| # | Description | Page # |
|----|---|--------|
| 15 | Impreza Sedan Spoiler Changes | 2 |

There is a part number change to the rear spoiler kits on all 2002 and up Impreza sedans. The new kit provides an easier installation and a cleaner look. Part #E7210FE501 and E7210FE502 will be available consecutively.

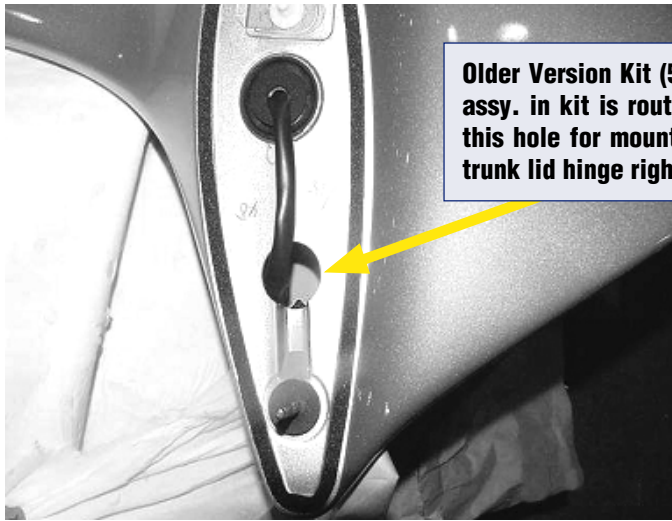
The most important difference in the "502" is the retention cable. It is affixed to the spoiler through front mounting stud. This means that no holes have to be drilled into the decklid for the retention cable. Additionally, the seal around the cable and removal and reinstallation of hinge bolts is no longer required.

Older Version Kit (501): Cable assy. in kit is routed through this hole for mounting on the trunk lid hinge right and left.

New Version Kit (502): Has pre-installed cable that is incorporated with the front stud on each side of the spoiler.

2) If a vehicle had a spoiler previously installed (kit #501) and only kit #502 is available, the installer will need to ensure that the sheet metal foam piece is reinstalled to provide a tight seal around the hole previously drilled for the cable. A new sheet metal foam piece (part # E7210FE520) is available if the original foam piece is not reusable.
